PR/0849/22

Record of Executive Business and Chief Executive's Order

Reg. Reference: SD22A/0015 **Application Date:** 17-Jan-2022
Submission Type: Additional **Registration Date:** 09-Jun-2022
Information
Correspondence Name and Address: Ban Dubh Building Design Ban Dubh Building
Design, Ban Dubh, Mackeys Cross, Clogheen, Cork
Proposed Development: Detached two storey house with new vehicular
entrance to side of 54 Fernwood Avenue as per
previously granted application SD16A/155
Location: 54, Fernwood Avenue, Dublin 24
Applicant Name: Niall Murphy
Application Type: Permission

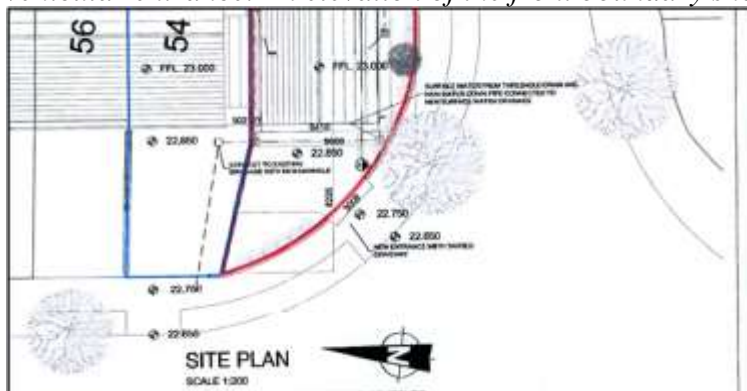
The proposed vehicular entrance has an acceptable width of 3008mm but it's location on a corner would be unacceptable as it would endanger public safety by reason of traffic hazard.

The submitted drawings do not show the heights of the boundary wall and pillars at the vehicular entrance. An elevation of the front boundary should be submitted for agreement

WEST ELEVATION

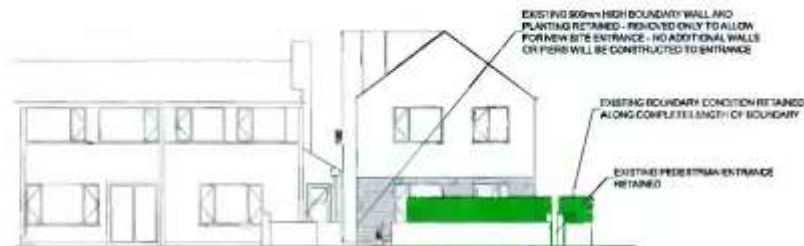
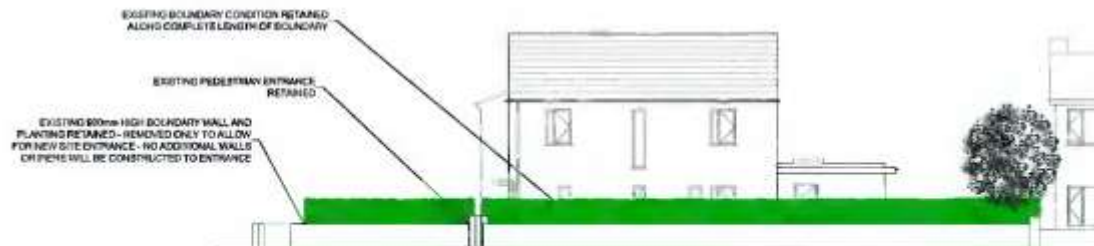
The applicant is requested to submit a proposed contiguous elevation for this current application showing the front elevation of the proposed dwelling and the front elevation of the existing dwelling.

2. Street Elevations are provided in drawing

The Planning Authority considers the applicant has satisfactorily responded to the request for additional information for this item.

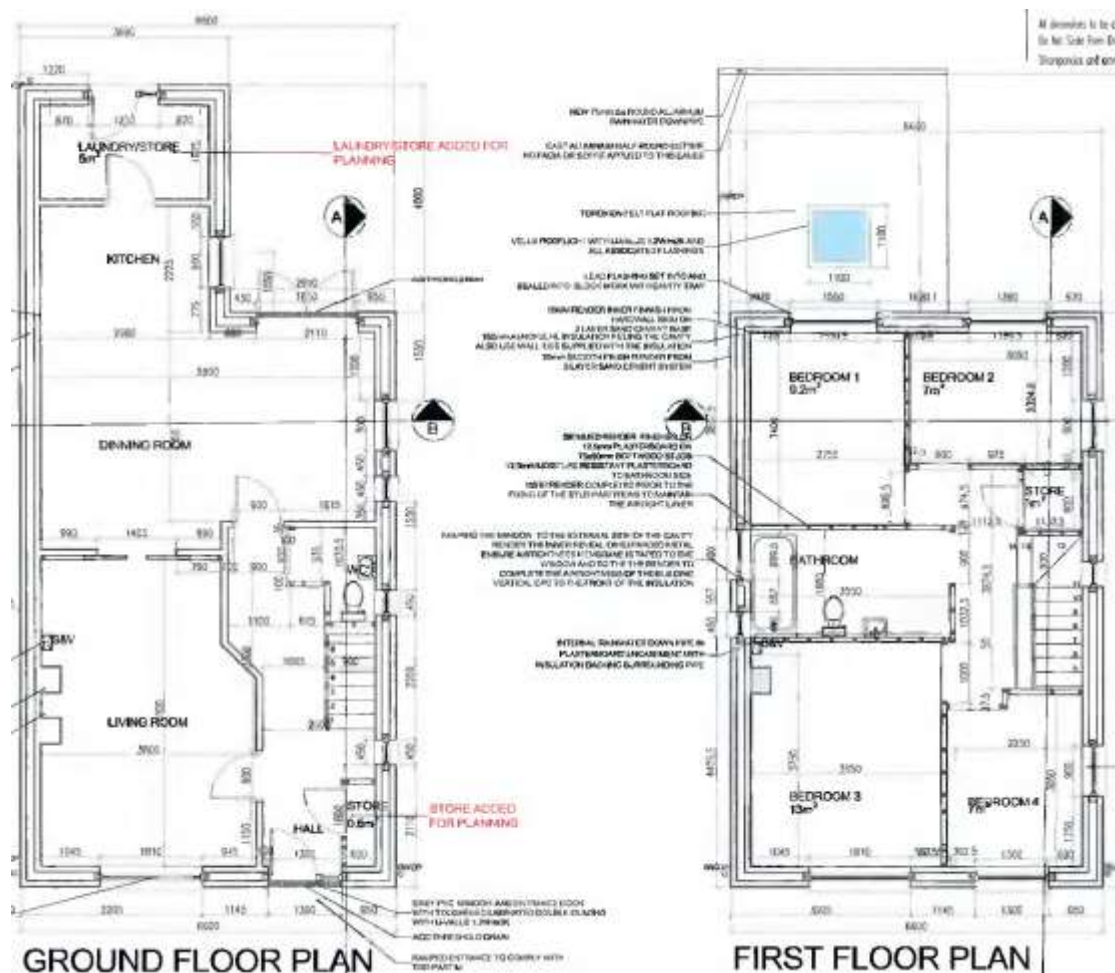
To comply with Section 11.3.1 Residential (iv) Dwelling Standards the floor area of the main bedroom must be at least 13sq.m. For this proposal the area of the main bedroom (bed 3) is 11.4sq.m. which is slightly below the required standard and would not comply. To comply with Section 11.3.1 Residential (iv) Dwelling Standards the floor area of a double bedroom must be a minimum of 11.4sq.m. To comply with Section 11.3.1 Residential (iv) Dwelling Standards the floor area of a single bedroom must be a minimum of 7.1sq.m. Therefore bed 2 (6.9sq.m.) and bed 4 (5.2sq.m.) do not comply. The applicant is requested to submit revised scaled and dimensioned drawings clearly indicating whether each bedroom is a single or a double bedroom. The applicant is requested to submit revised drawings for all bedrooms clearly showing how this complies with Section 11.3.1 Residential (iv) Dwelling Standards of the SDCC Development Plan 2016-2022.

3. Revised floor plans shown in drawing 012/18-04 address the required areas in bedrooms in Section 11.3.1 Residential Dwelling Standards of the SDCC development Plan 2016-2022

Revised bedroom sizes now broadly comply with Section 11.3.1 Residential (iv) Dwelling Standards of the SDCC Development Plan 2016-2022. Bedroom 1 has decreased in size from 9.8sq.m. to 9.2sq.m.. The floor area for bedroom 1 would comply for a single bedroom but not for a double bedroom (min 11.4sq.m.). Bedroom 2 now measures 7sq.m. which is broadly in compliance with the minimum of 7.1sq.m. for a single bedroom. Bedroom 3 now measures 13sq.m. which complies with the minimum floor area for the main bedroom. Bedroom 4 now

measures 7sq.m. which is broadly in compliance with the minimum of 7.1sq.m. for a single bedroom. The Planning Authority considers the applicant has satisfactorily responded to the request for additional information for this item.

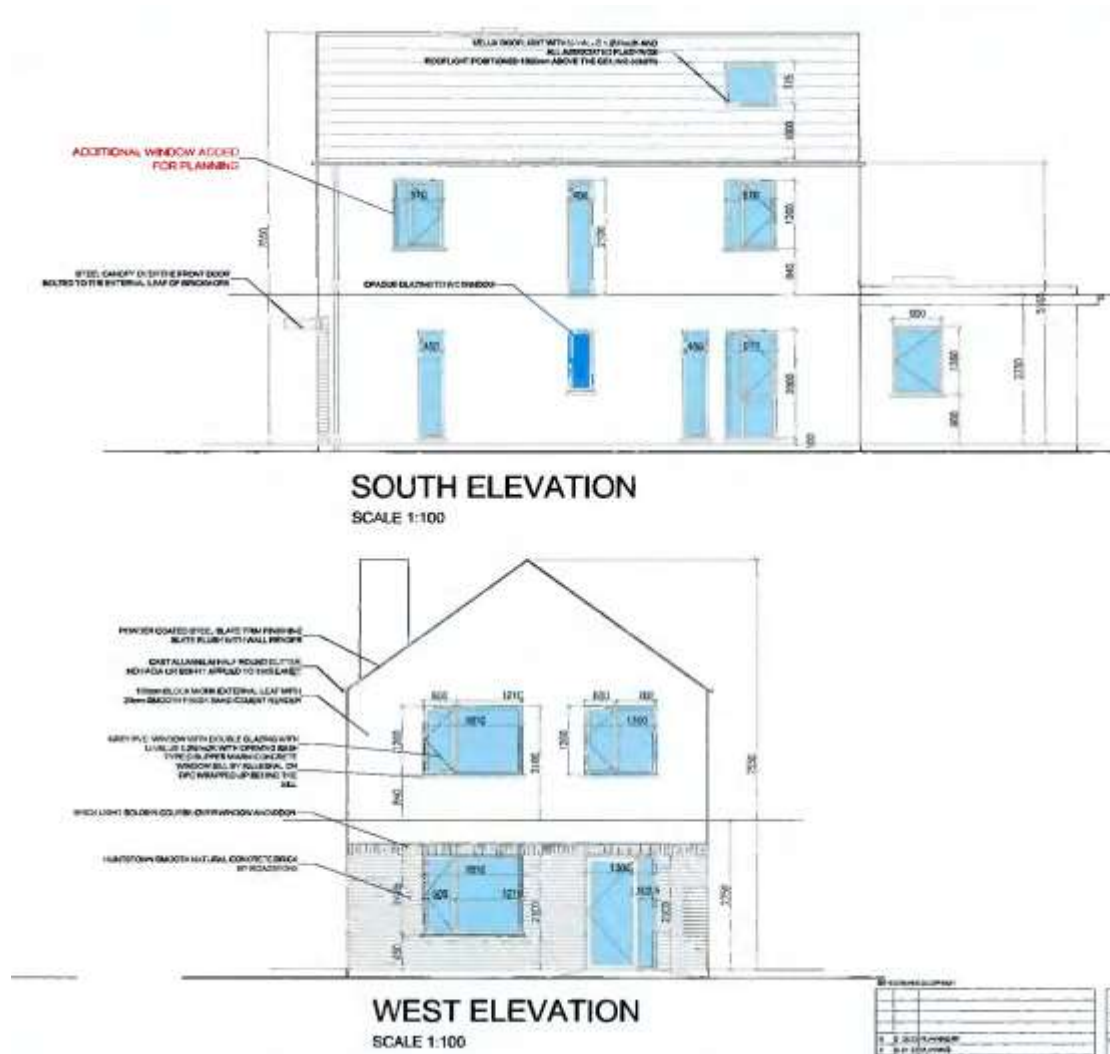
To provide for improved dual frontage and improved passive surveillance of the public realm an additional window should be inserted on the southern elevation for bed 4. Therefore, the

applicant is requested to submit revised drawings clearly showing the insertion of an additional window for bed 4 on the southern elevation.

4. Drawing 012/18-05 address the dual frontage of the building with the addition of an extra window to the south facade.

The revised drawing submitted shows for an additional window to be inserted on the southern elevation for bed 4 on the southern elevation. The Planning Authority considers the applicant has satisfactorily responded to the request for additional information for this item.

New revised Ground Floor with proposed laundry/store (5sq.m additional floor space)

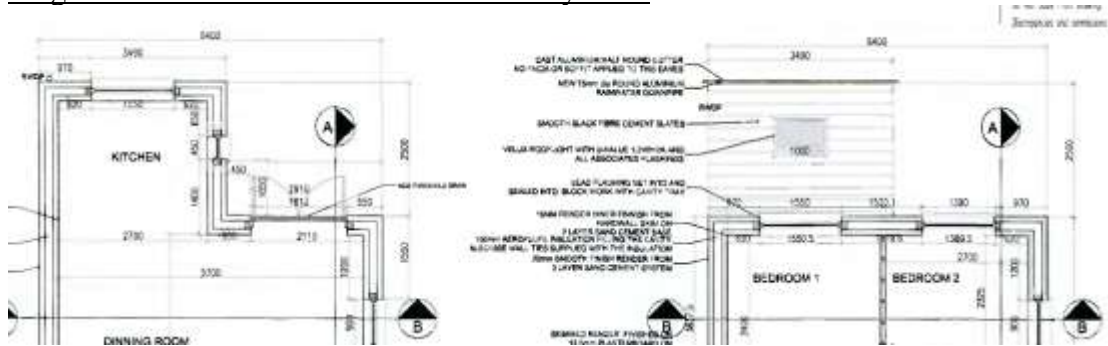
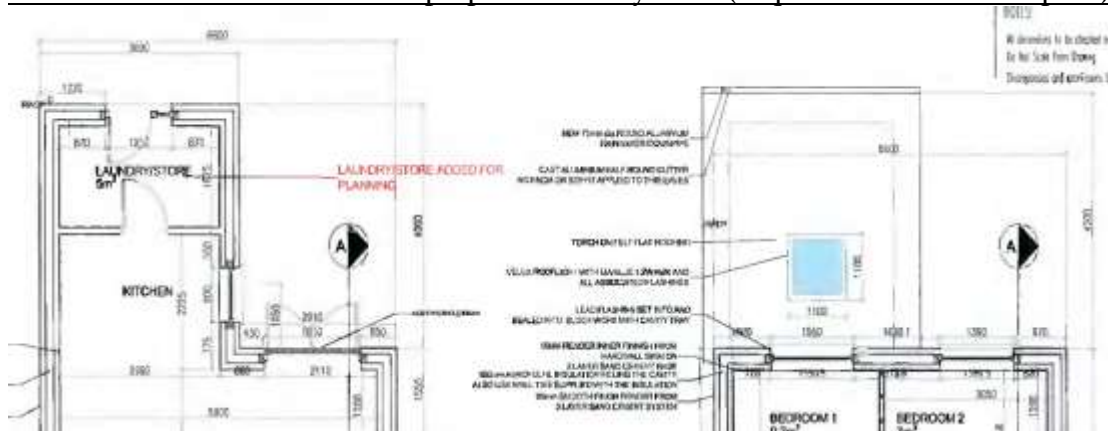
The drawings submitted show no dedicated storage to be provided for the proposal. This would not comply with the minimum storage area requirements as per the Quality Housing for Sustainable Communities, Best Practice Guidelines for Delivering Homes Sustaining Communities 2007. A minimum of 6sq.m of dedicated storage space should be provided for a 4 bed, 7 person, 2 storey house. Therefore, the level of storage to be provided would not comply with the above policy. The applicant is requested to submit revised drawings clearly showing the appropriate level of dedicated storage will be provided to comply with the Quality Housing for Sustainable Communities, Best Practice Guidelines for Delivering Homes Sustaining Communities 2007.

5. Drawing 012/18-04 address outstanding dedicated storage area as required by the Quality Housing for Sustainable Communities, Best Practice Guidelines for Delivering Homes Sustaining Communities 2007.

Revised drawings submitted show c.6.6sq.m of dedicated storage will now be provided. This complies with the minimum 6sq.m. for a 4 bed, 7 person, 2 storey house. This would comply with the Quality Housing for Sustainable Communities, Best Practice Guidelines for Delivering Homes Sustaining Communities 2007. It is noted that the ground floor will be extended further outwards at the rear by an additional 1.7m to provide for the laundry/store (5sq.m.). The kitchen and laundry/store will now have a flat parapet roof (parapet height c.3.375m) instead of the previously proposed mono-pitched roof. The Planning Authority considers the applicant has satisfactorily responded to the request for additional information for this item.

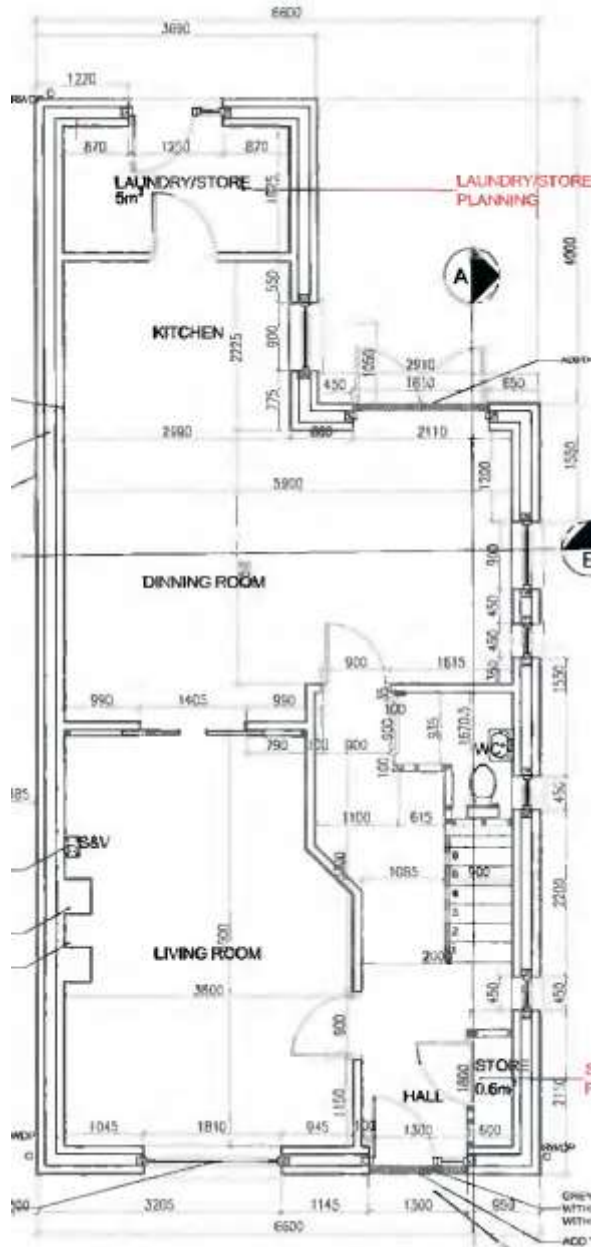
At 3.6m the living room width will be slightly below the 3.8m set out for unobstructed living room width as per Quality Housing for Sustainable Communities, Best Practice Guidelines for Delivering Homes Sustaining Communities 2007. Therefore, this would not comply. The applicant is requested to submit appropriate revised scaled and dimensioned drawings to address this issue so that it complies with the Quality Housing for Sustainable Communities, Best Practice Guidelines for Delivering Homes Sustaining Communities 2007.

6. Drawing 012/18-04 address the highlighted unobstructed living room width as per Quality Housing for Sustainable Communities, Best Practice Guidelines for Delivering Homes Sustaining Communities 2007.

At 3.8m the living room width now complies with the 3.8m set out for unobstructed living room width as per Quality Housing for Sustainable Communities, Best Practice Guidelines for Delivering Homes Sustaining Communities 2007. The Planning Authority considers the applicant has satisfactorily responded to the request for additional information for this item.

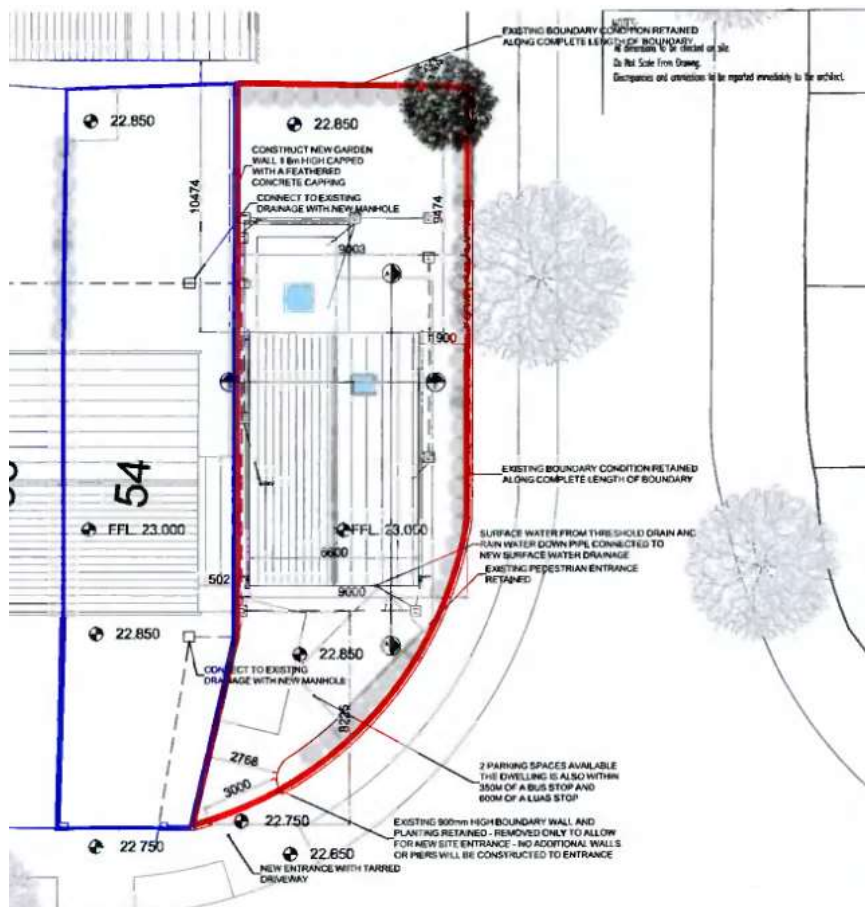
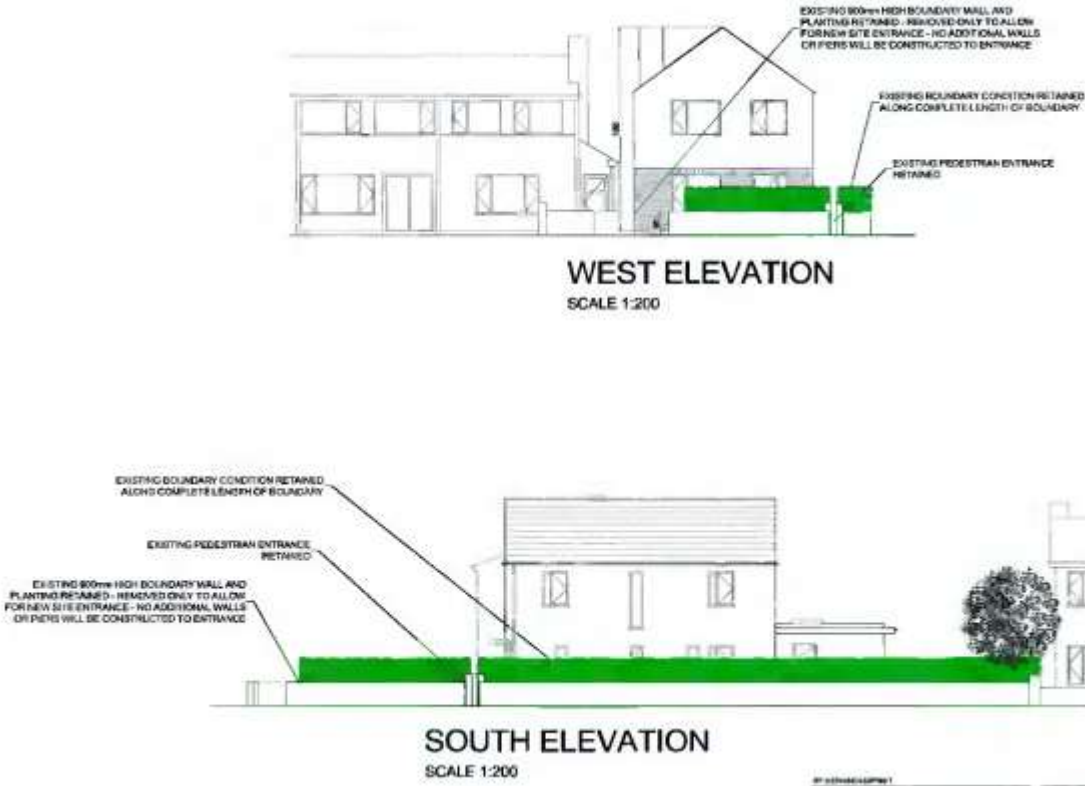
No boundary treatment details have been submitted for the proposal. Therefore, the applicant is requested to submit clear boundary treatment details in both plan and elevation for all front, rear and all side boundaries. All proposed boundary treatment details should comply with the SDCC Development Plan 2016-2022.

7. Drawings 012/18-03 012/18-08 Address the site boundary treatments. There is no proposed modification to the existing site boundary as it exists. It will remain exactly as it is except in the location where the new entrance is provided.

The Planning Authority considers the applicant has satisfactorily responded to the request for additional information for this item.
